# Rezoning Transportation Analysis

Petition Number: 2021-079

Date	Description
08-02-2021	First Review (WB)

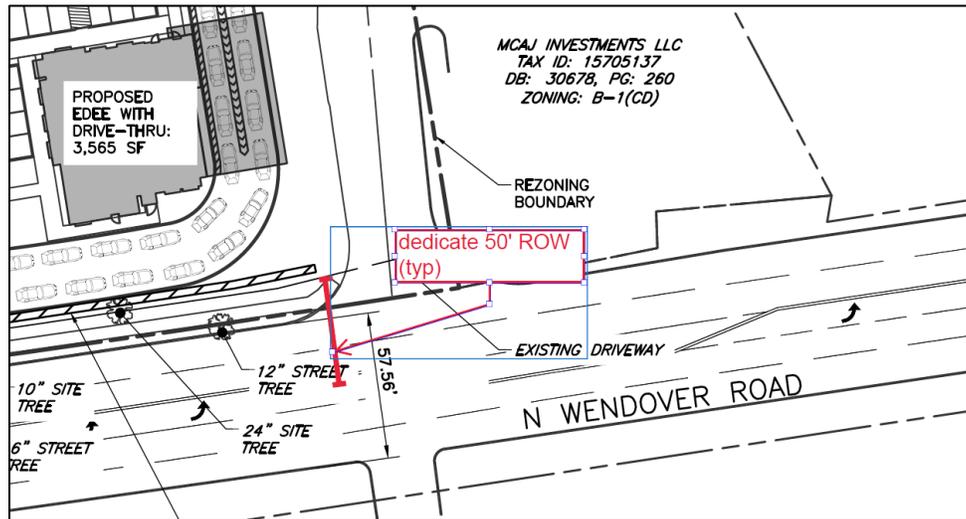
1. **Curblines:** The proposed zoning district has a setback measured from back of the existing or proposed future curblines.
  - a. **North Wendover Road:** The future location of curb and gutter is in its existing location.

Label and dimension the curb and gutter from the centerline for each road on the site plan.

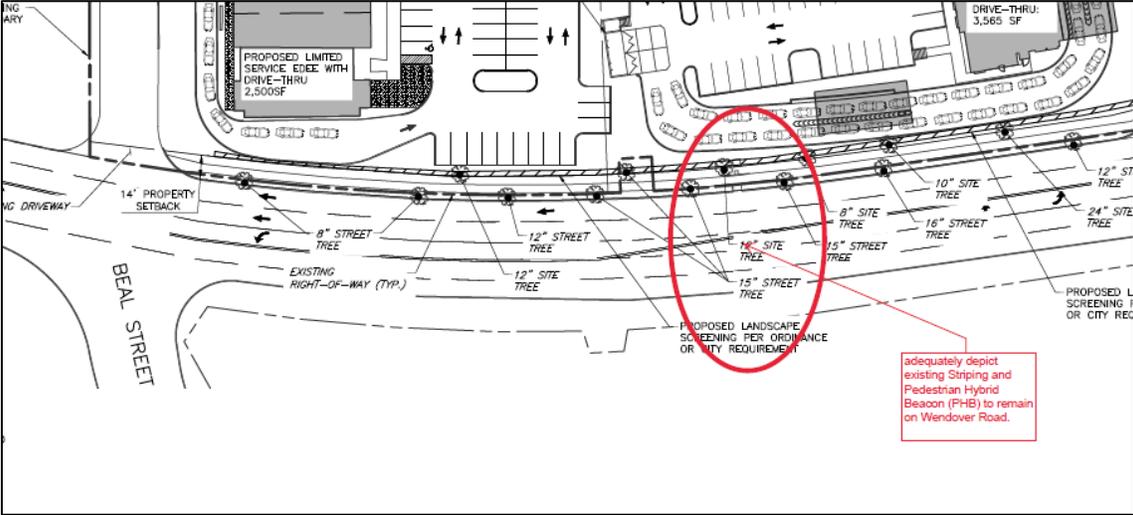
4. Site plan and conditional note(s) revisions are needed to commit to installing a 12' multi-use path with an 8' planting strip to meet the Charlotte BIKES Policy.
5. Revise site plan to adequately depict the existing Pedestrian Hybrid Beacon (PHB) to remain on Wendover Road.

*Approximate location of Proposed Pedestrian Access*

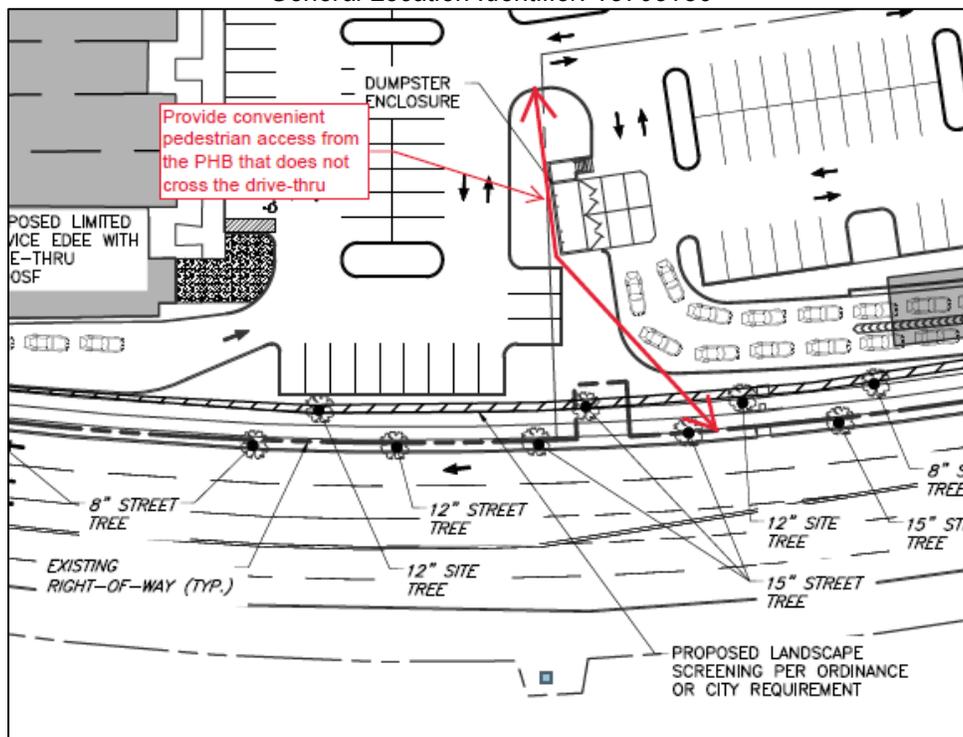
- 6. Revise site plan and conditional note(s) to commit to provide convenient pedestrian access from the PHB into the site without crossing the drive thru.
